VICTORIA'S SECRET
NORTH POINT MALL
SPACE #1050
1000 NORTH POINT CIRCLE
ALPHARETTA, GA 30022

NO.	REVISION	DATE
1	NO ADDENDUM - LANDLORD COMMENTS	
2	MASTER UPDATES (1515a.01 & 015a)	01/02/2015

STOREFRONT
DETAILS

DRAWING NUMBER:
A08.12

VERTICAL SECTION AT DISPLAY WINDOW

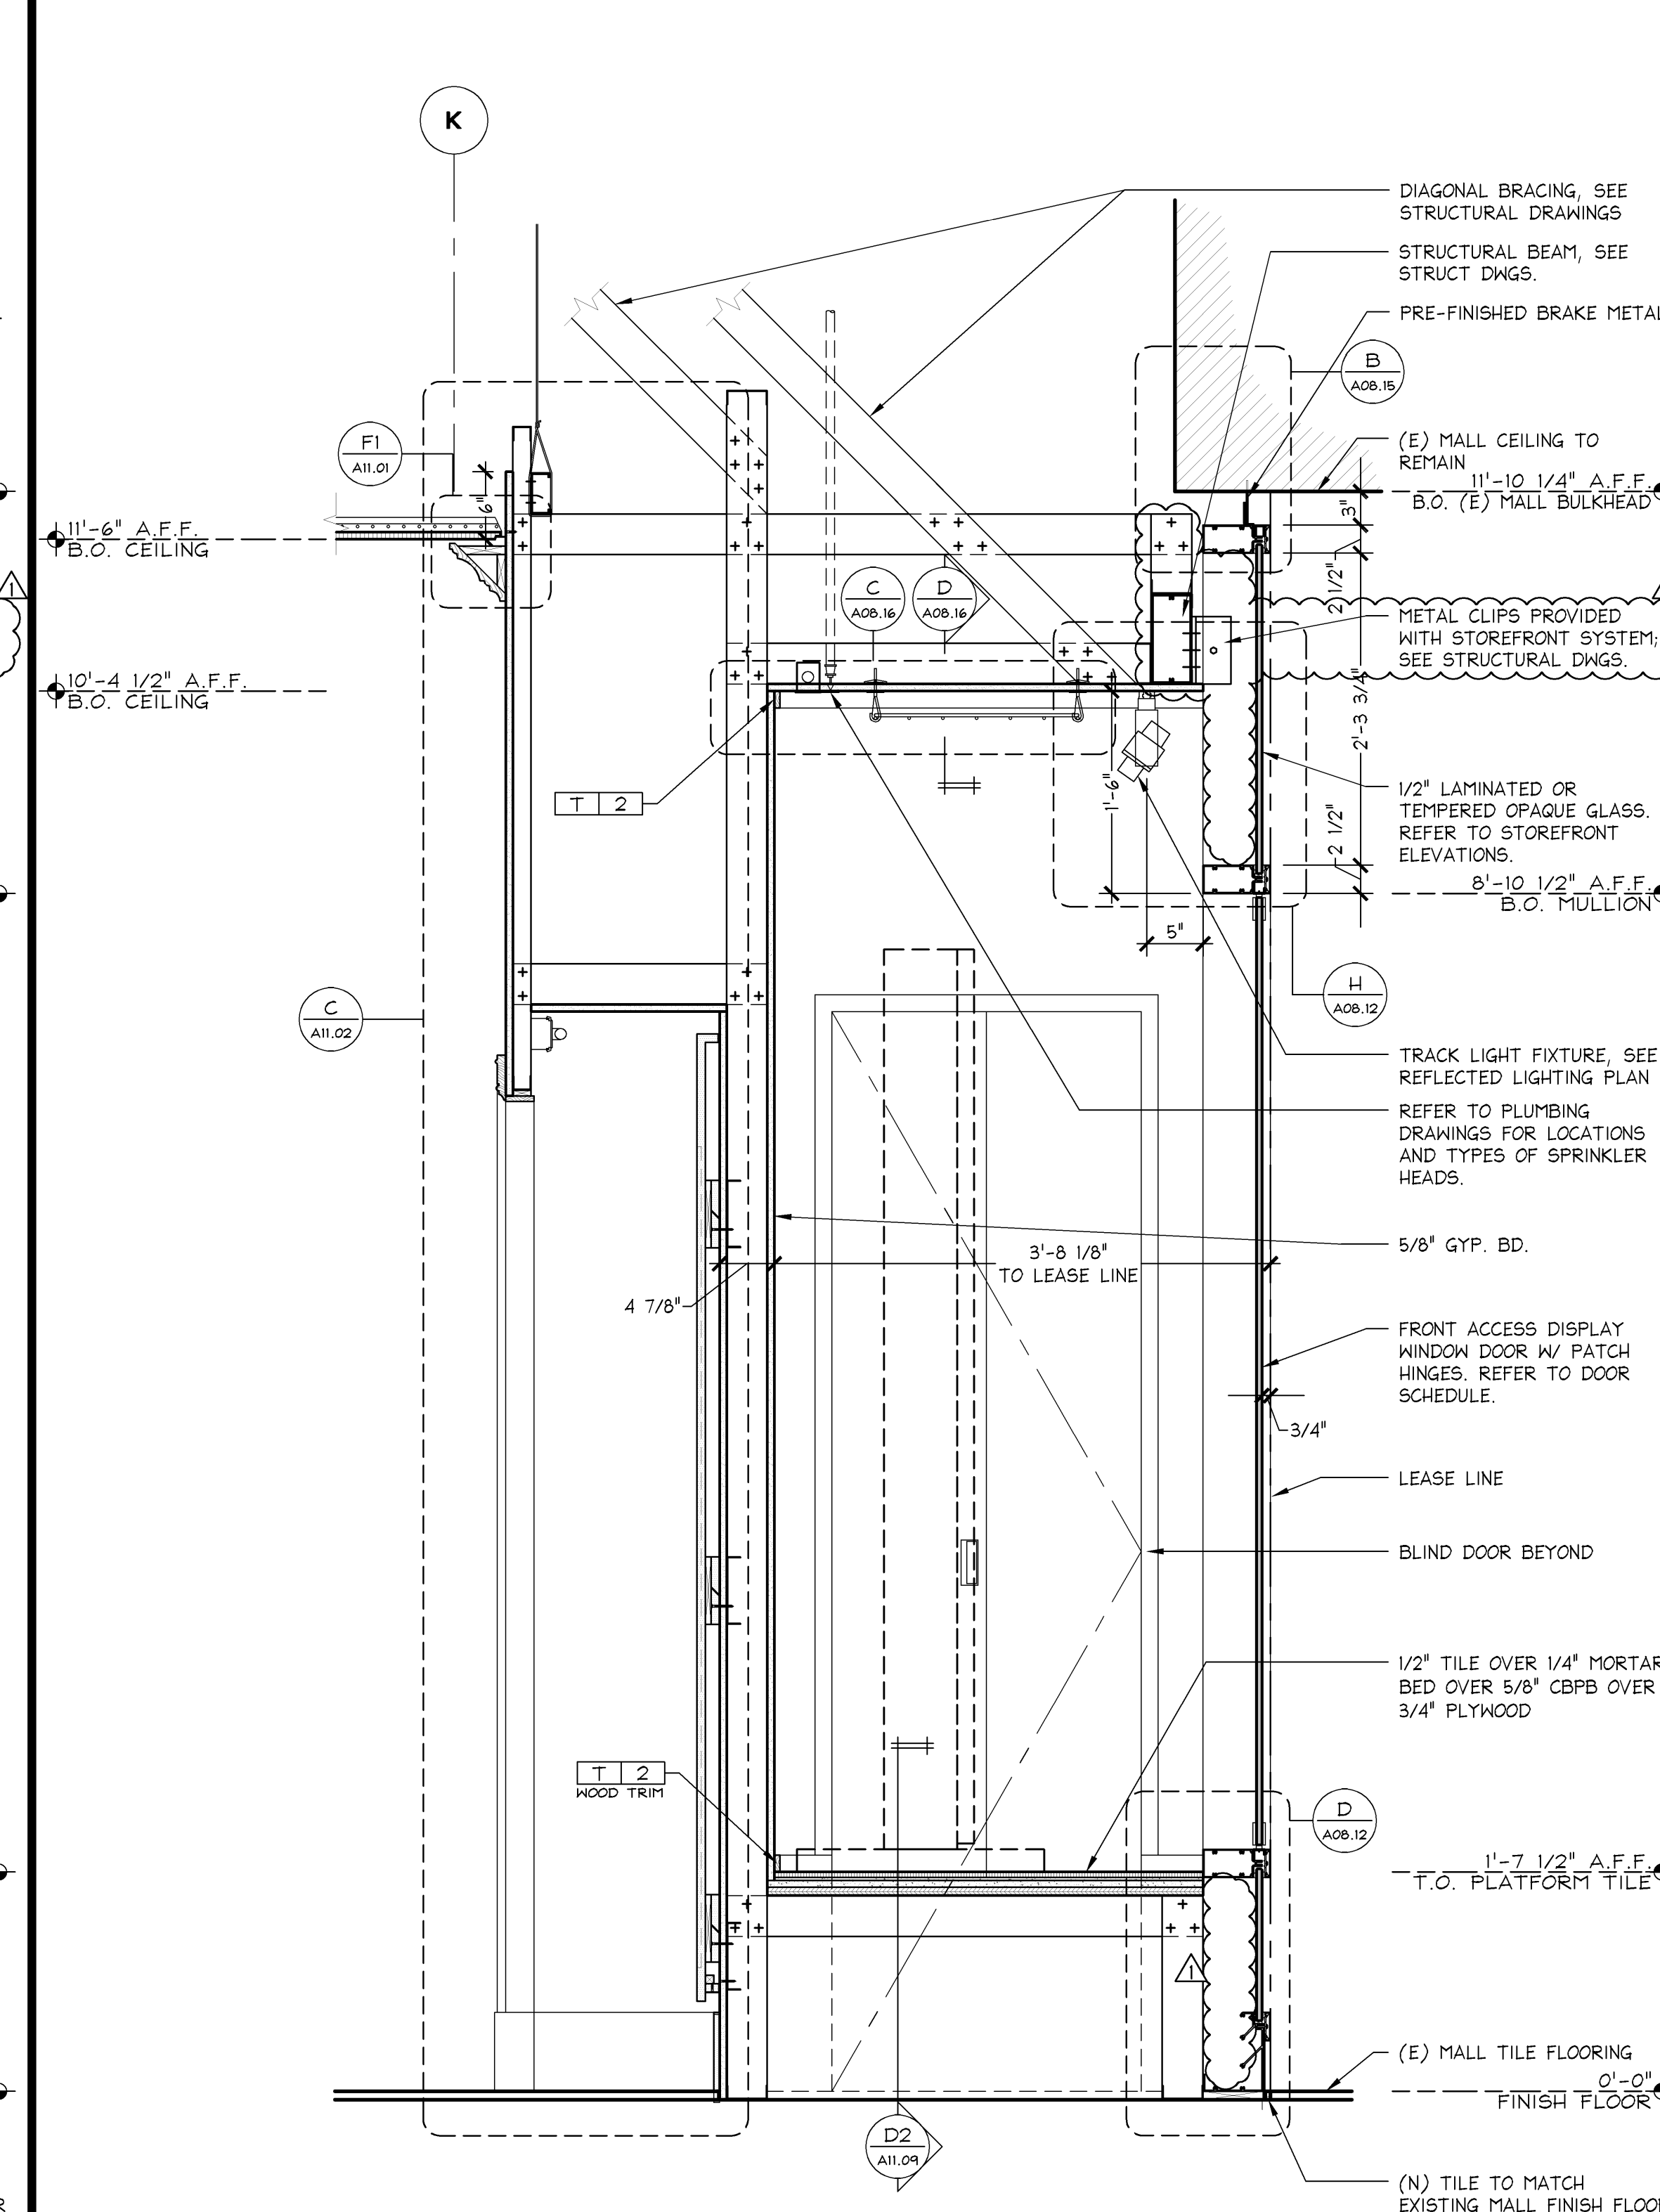
- LL COMMENTS: G.C. TO COMPLY.
- ATTACHMENT TO LANDLORD'S STRUCTURE FOR LATERAL SUPPORT ONLY - COORDINATE METHOD OF ATTACHMENT ON SITE WITH THE MALL OPERATIONS MANAGER.
